AMP NORTH ADDITION - PREBID RFIS							
RFI no.	Question	Question Date	Images	Answer	Answered By	Answer Date	Images
1	B-1 Base on A002 is not specified. Please indicate product.	7/6/2026		Johnsonite Taditional Vinyl 1/8", 4", Black @ Back of House areas	ddept	7/13/2026	
2	A003 calls for CPT-01 (carpet at stairs) for \$75/sy but no vendor or manufacturer are specified. Is this to be an allowance?	7/6/2026		This is an estimate allowance. Custom Carpet is being developed. The vendor is Tarkett Hospitality / contact Erin Rink erin.rink@tarkett.com	Meredith	7/15/2026	
3	Please define scope of work at fence / gate	7/6/2026		Ddept: Existing fence / gate to be removed to accommodate new construction. Existing fence / gate to remain adjacent to new construction. Crafton Tull: fence/gate will need to be tied in adjacent to new building to maintain access control.	ddept	7/13/2026	
4	Electrical power plan does not show circuitry for patron facing outlets under bars per note 3/A120. Please advise.	7/6/2026		Three (3) patron facing outlets to be provided at each bar - 9 total (3 @ 3 bars)	ddept	7/15/2026

AMP NORTH ADDITION - PREBID RFIS

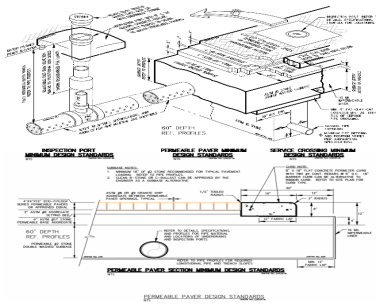
26	Please provide insulation schedules for domestic cold water, hot water, & storm water?	7/10/2026		IMEG: See attached image	IMEG	7/13/2026	<table><tr><th colspan="6">PLUMBING PIPING INSULATION SCHEDULE</th></tr><tr><th rowspan="2">DESCRIPTION</th><th rowspan="2">INSULATION TYPE</th><th colspan="5">MINIMUM INSULATION THICKNESS PER ASHRAE 90.1</th></tr><tr><th colspan="5">NOMINAL PIPE SIZE RECOMMENDATIONS</th></tr><tr><th></th><th></th><th><1</th><th>1 TO <1-1/2</th><th>1-1/2 TO <4</th><th>4 TO <8</th><th>>8</th></tr><tr><td>DOMESTIC COLD WATER PIPING BELOW GRADE</td><td>PVC OR HDPE JACKET ONLY</td><td>1</td><td>1</td><td>1.5</td><td>1.5</td><td>1.5</td></tr><tr><td>CONDENSATE PIPING ABOVE GRADE</td><td>ELASTOMERIC ADHASTHENA COMPLAINT JACKET IN AIR PLENUM SPACES</td><td>0.5</td><td>1</td><td>1</td><td>1</td><td>1.5</td></tr><tr><td>PVC WASTE VENT AND WASTE DRAIN IN AIR PLENUM SPACE</td><td>COMPRESSED FIBERGLASS OR ELASTOMERIC WITH ASTHENA COMPLAINT JACKET</td><td>0.5</td><td>0.5</td><td>0.5</td><td>0.5</td><td>0.5</td></tr><tr><td>PVC AND CAST IRON ROOF DRAINS IN ALL AREAS ABOVE GRADE</td><td>COMPRESSED FIBERGLASS OR ELASTOMERIC WITH ASTHENA COMPLAINT JACKET</td><td>1</td><td>1</td><td>1.5</td><td>1.5</td><td>1.5</td></tr><tr><td>WATER COOLER TRAPS, ALL EXPOSED LAVATORY AND SINK TRAPS, TRAPPEES, HOT AND COLD WATER SUPPLY, LINE/DRAINAGE VALVES TO THESE DEVICES</td><td>EQUAL TO TUBERO 100 6.2 PIPE COVER</td><td>0.125</td><td>0.125</td><td>0.125</td><td>0.125</td><td>0.125</td></tr><tr><td>DOMESTIC HOT WATER AND HOT WATER RETURN PIPING BELOW GRADE</td><td>ELASTOMERIC OR FOAM. ENCAPSULATE WITH PVC OR HDPE JACKET</td><td>1</td><td>1</td><td>1.5</td><td>1.5</td><td>1.5</td></tr><tr><td>DOMESTIC COLD WATER, HOT WATER AND HOT WATER RETURN PIPING ABOVE GRADE</td><td>ELASTOMERIC ADHASTHENA COMPLAINT JACKET IN AIR PLENUM SPACES</td><td>1</td><td>1</td><td>1.5</td><td>1.5</td><td>1.5</td></tr><tr><td>PVC WASTE DRAIN IN WALLS, AND WASTE VENT IN ALL AREAS ABOVE GRADE</td><td>COMPRESSED FIBERGLASS OR ELASTOMERIC WITH ASTHENA COMPLAINT JACKET</td><td>1"</td><td>1"</td><td>1.5"</td><td>1.5"</td><td>1.5"</td></tr></table>	PLUMBING PIPING INSULATION SCHEDULE						DESCRIPTION	INSULATION TYPE	MINIMUM INSULATION THICKNESS PER ASHRAE 90.1					NOMINAL PIPE SIZE RECOMMENDATIONS							<1	1 TO <1-1/2	1-1/2 TO <4	4 TO <8	>8	DOMESTIC COLD WATER PIPING BELOW GRADE	PVC OR HDPE JACKET ONLY	1	1	1.5	1.5	1.5	CONDENSATE PIPING ABOVE GRADE	ELASTOMERIC ADHASTHENA COMPLAINT JACKET IN AIR PLENUM SPACES	0.5	1	1	1	1.5	PVC WASTE VENT AND WASTE DRAIN IN AIR PLENUM SPACE	COMPRESSED FIBERGLASS OR ELASTOMERIC WITH ASTHENA COMPLAINT JACKET	0.5	0.5	0.5	0.5	0.5	PVC AND CAST IRON ROOF DRAINS IN ALL AREAS ABOVE GRADE	COMPRESSED FIBERGLASS OR ELASTOMERIC WITH ASTHENA COMPLAINT JACKET	1	1	1.5	1.5	1.5	WATER COOLER TRAPS, ALL EXPOSED LAVATORY AND SINK TRAPS, TRAPPEES, HOT AND COLD WATER SUPPLY, LINE/DRAINAGE VALVES TO THESE DEVICES	EQUAL TO TUBERO 100 6.2 PIPE COVER	0.125	0.125	0.125	0.125	0.125	DOMESTIC HOT WATER AND HOT WATER RETURN PIPING BELOW GRADE	ELASTOMERIC OR FOAM. ENCAPSULATE WITH PVC OR HDPE JACKET	1	1	1.5	1.5	1.5	DOMESTIC COLD WATER, HOT WATER AND HOT WATER RETURN PIPING ABOVE GRADE	ELASTOMERIC ADHASTHENA COMPLAINT JACKET IN AIR PLENUM SPACES	1	1	1.5	1.5	1.5	PVC WASTE DRAIN IN WALLS, AND WASTE VENT IN ALL AREAS ABOVE GRADE	COMPRESSED FIBERGLASS OR ELASTOMERIC WITH ASTHENA COMPLAINT JACKET	1"	1"	1.5"	1.5"	1.5"

PLUMBING PIPING INSULATION SCHEDULE																																																																																								
DESCRIPTION	INSULATION TYPE	MINIMUM INSULATION THICKNESS PER ASHRAE 90.1																																																																																						
		NOMINAL PIPE SIZE RECOMMENDATIONS																																																																																						
		<1	1 TO <1-1/2	1-1/2 TO <4	4 TO <8	>8																																																																																		
DOMESTIC COLD WATER PIPING BELOW GRADE	PVC OR HDPE JACKET ONLY	1	1	1.5	1.5	1.5																																																																																		
CONDENSATE PIPING ABOVE GRADE	ELASTOMERIC ADHASTHENA COMPLAINT JACKET IN AIR PLENUM SPACES	0.5	1	1	1	1.5																																																																																		
PVC WASTE VENT AND WASTE DRAIN IN AIR PLENUM SPACE	COMPRESSED FIBERGLASS OR ELASTOMERIC WITH ASTHENA COMPLAINT JACKET	0.5	0.5	0.5	0.5	0.5
